IREDELL COUNTY HEALTH DEPARTMENT

Upgrade to 5 Bedrooms

PERMIT # 223990

IMPROVEMENT PERMIT / AUTHORIZATION TO CONSTRUCT / OPERATION PERMIT / EXISTING SYSTEM

INITIAL SITE SKETCH

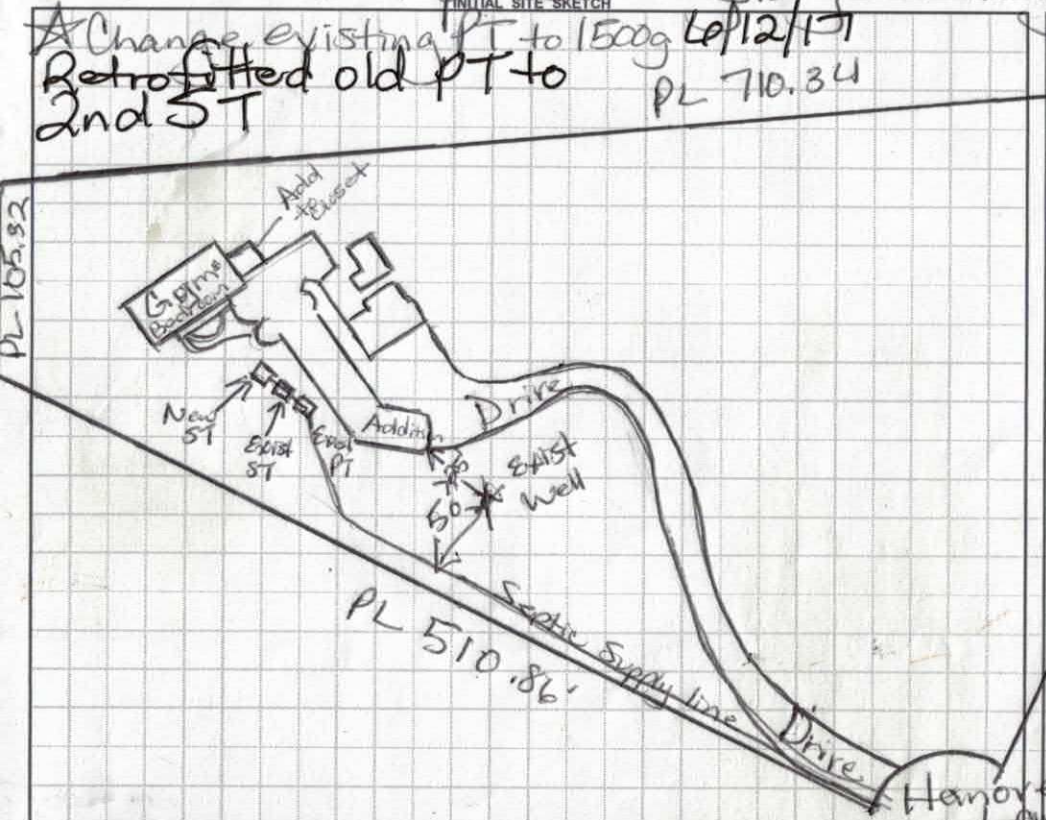
Comments / Conditions: ★ Either add an extra 1000 gal Septic tank before existing 1000g ST & All Sewage must go through both Septic Tanks OR replace existing 1000g ST with 1500g ST. Add an additional drainline @ 120ft. Use same tap size as existing drainlines. 6/12/17 Installed Quick 4 122ft after Cap set 22# pressure

AS BUILT SKETCH

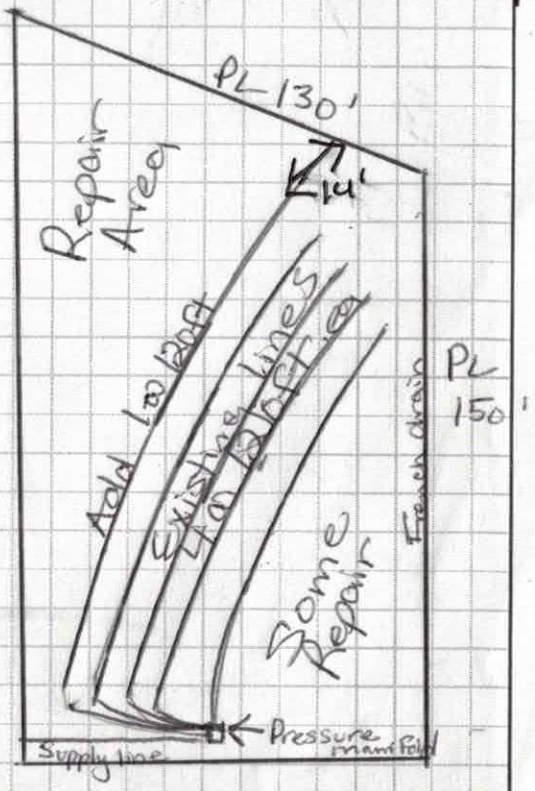
★ Change existing PT to 1500g 6/12/17

Retrofitted old PT to 2nd ST

INITIAL SITE SKETCH

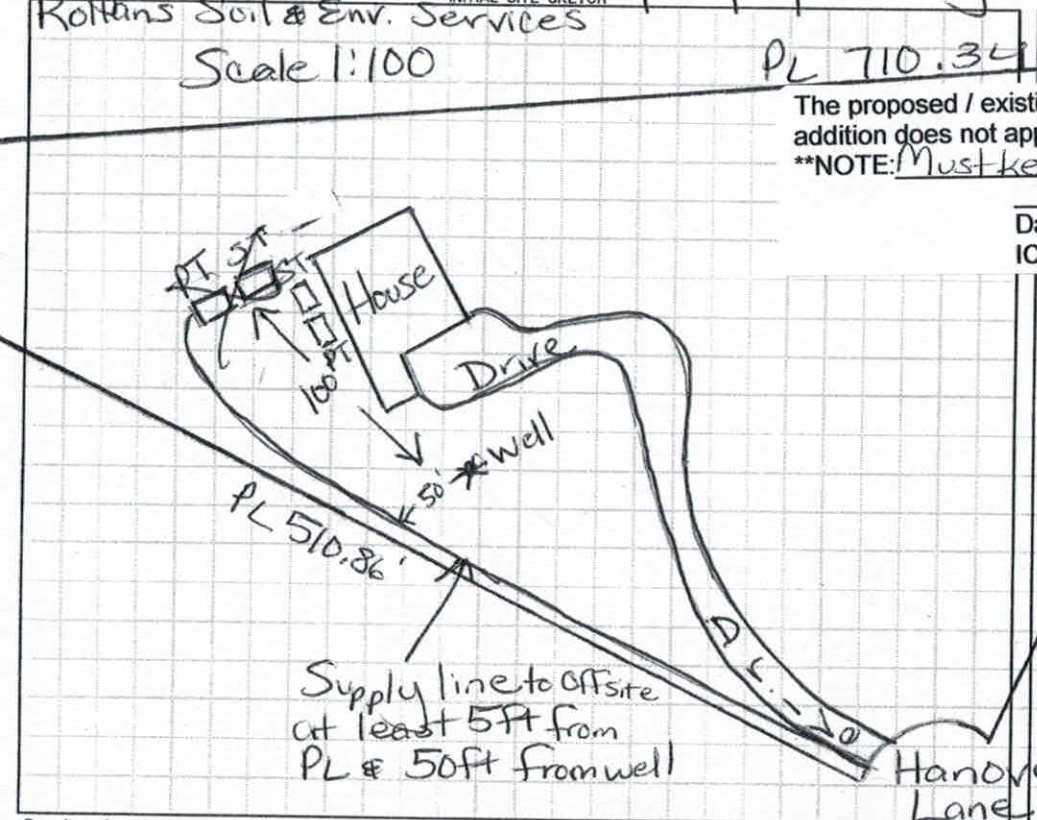
The proposed / existing Inground Swimming Pool addition does not appear to impact the existing septic system.

**NOTE: Must keep Pool cut at least 15ft from Septic
